Comments on a substantive application under section 53 of the Fast-track Approvals Act 2024

Mt Welcome, Pukerua Bay, Porirua

Fast-track application number	FTAA-2603-1181
GW file number	FTA260348
Project name	Mt Welcome, Pukerua Bay, Porirua
Applicant	Pukerua Property Group Limited Partnership
Date	28 July 2026

Author	Andrew Banks	Senior Resource Advisor, Environmental Regulation	
Reviewed by	Richard Percy	Team Leader, Environmental Regulation	
Approved by	Fathima Iftikar	Group Manager Environment

Figure 2: location of proposed "retention wetlands". Source:

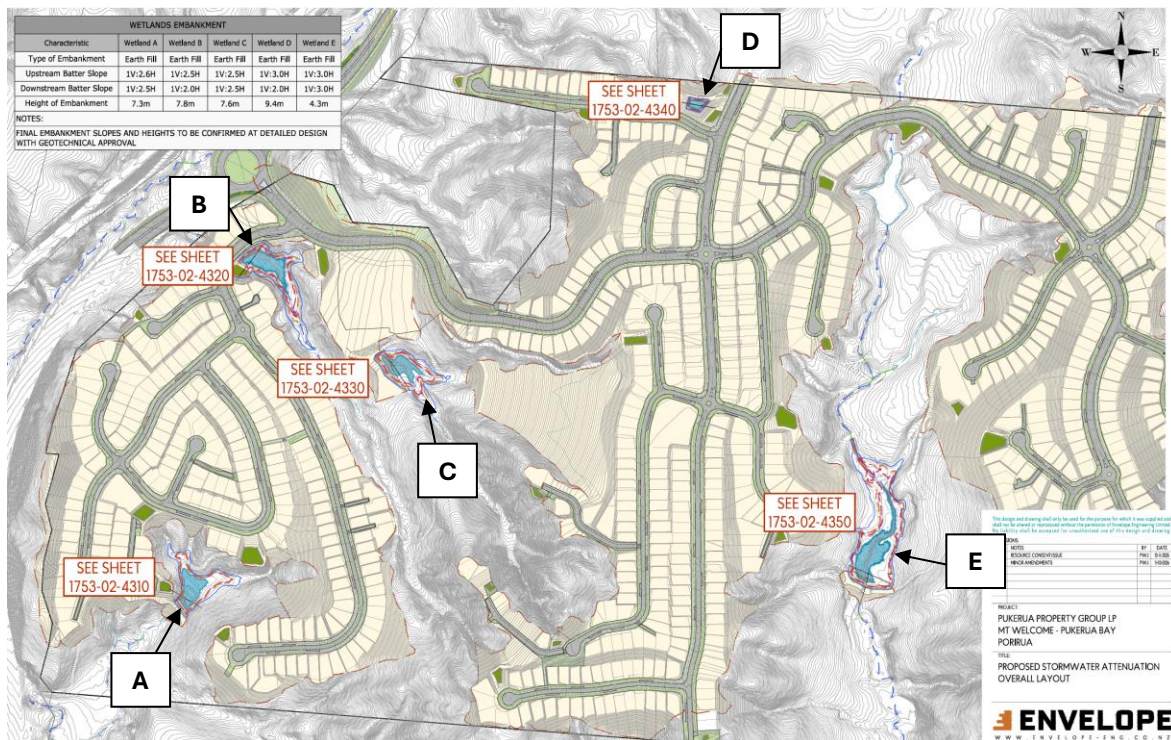
68. The Applicant has proposed the establishment of five “retention wetlands”⁴⁹ as part of the proposal (Figure 2). The primary purpose of the retention wetlands is explained in the SMP as follows: “the wetland retention ponds provide both water quality and quantity control – retaining and detaining runoff from frequent, low-intensity events and storing flows up to the 1% AEP storm”⁵⁰. In other words, they are intended as a constructed stormwater management device. This is reinforced by the fact that the Applicant proposes to vest the land on which the devices are located to PCC/Tiaki Wai as a drainage reserve.

74. Greater Wellington and its experts have identified a range of technical issues with the proposed retention wetlands. Table 4 below summarises these technical issues, which are explained in detail in the technical comments provided by each expert. Greater Wellington understands that PCC and Tiaki Wai will also be commenting on the retention wetlands and suggests that the Panel considers Greater Wellington's comments alongside those of PCC and Tiaki Wai.

Figure 5: Earthworks cutting across streams and natural wetlands to the south-west of the site. Earthworks extent is shown in red dashed line. Source: Application Appendix 30-41 Overall Ecological Areas.

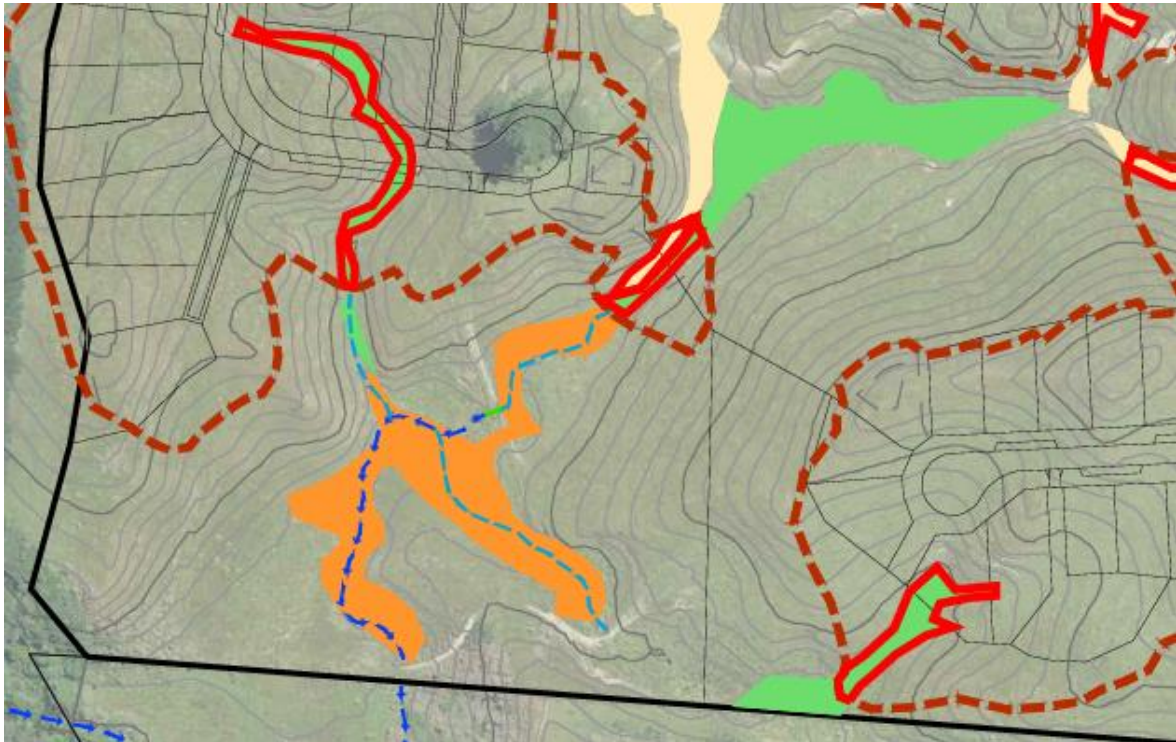
231. Mr McLean considers that the Application documents (including the DECMP) do not explain how setbacks from wetlands and streams (a) and locating sediment controls upstream of wetland areas (d) have been considered or will be implemented.¹³⁷ This will be a particular issue where earthworks cut across existing streams and natural inland wetlands, where a setback will not be possible. This occurs frequently throughout the proposed development. Figure 5 shows an example of this in the south-western extent of the site.
